MINOR AMENDMENT TO SITE PLAN

Case Numbers	Action	Fees	Case Numbers	Action	Fees
SI-2022-00326	AA

**RE: REQUEST FOR ADMINISTRATIVE AMENDMENT TO THE SITE
MAVERIK 650 JUAN TABO BLVD NW ALBUQUERQUE, NM 87123
DEVELOPMENT PLAN FOR BUILDING PERMIT PR-2018-001411**

MAVERIK
 690 JUAN TABO BLVD. NE
 SITE PLAN FOR BUILDING PERMIT

PROPOSED SITE PLAN

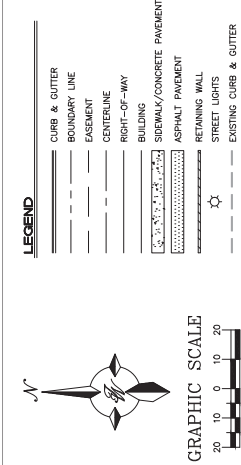
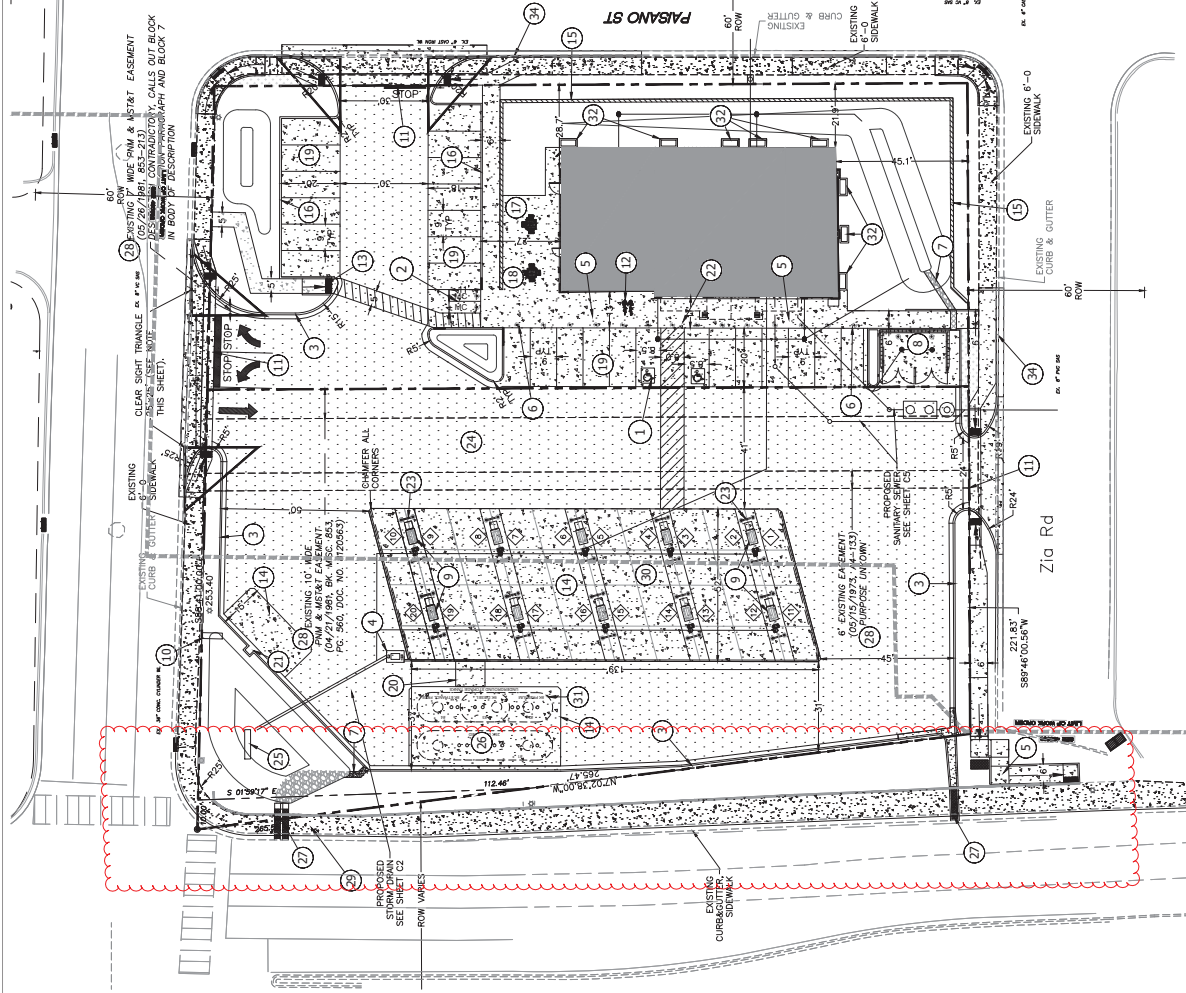
Tierra West, on behalf of MAVERIK, requests approval for an Administrative Amendment to the DRB-Site Plan for Building Permit. This project PR-2018-001411 was approved as a Site Development Plan for Building Permit on 05/08/2019 at DRB with conditions. This amendment is a result of modifications to the proposed site access. The original approval had a "right in only" lane off of Juan Tabo Blvd that was approved by the NMDOT. Maverik has indicated the proposed driveway and right turn lane on Juan Tabo Blvd are not needed for the store and we are removing them from the site plan. The proposed driveway along Juan Tabo Blvd. was intended to provide easier access to the site, bringing in more potential business. It was determined that the additional business would not justify the cost of the driveway and related infrastructure, therefore it was removed. As part of the amendment we have updated the Traffic Impact Study (TIS), which has removed this access and obtained approval from Traffic Engineering and the NMDOT.

The site has been completed and the offsite improvements were separated into two phases. Phase 1 has been fully built and closed out. Phase 2 included the proposed right in only driveway along Juan Tabo Blvd and right turn lane, which is what is being deleted. As mentioned the Traffic Impact Study has been amended and approved as of 01/26/2022. This amendment is also requesting to update the Infrastructure List (removing the right turn lane from the list) as well as updating the site development plans. We are proceeding in two steps the first is to process an Administrative Amendment application, removing the right turn lane, and then second we'll update the infrastructure list. If we can do those items concurrently we would appreciate it.

Attached are the previous approved plans as well as the proposed new DRB-Site Plan with the changes clouded. We have also included copies of the approved IIA list and the amended list in the event we can do this with the AA process. If we are missing anything else please let us know.
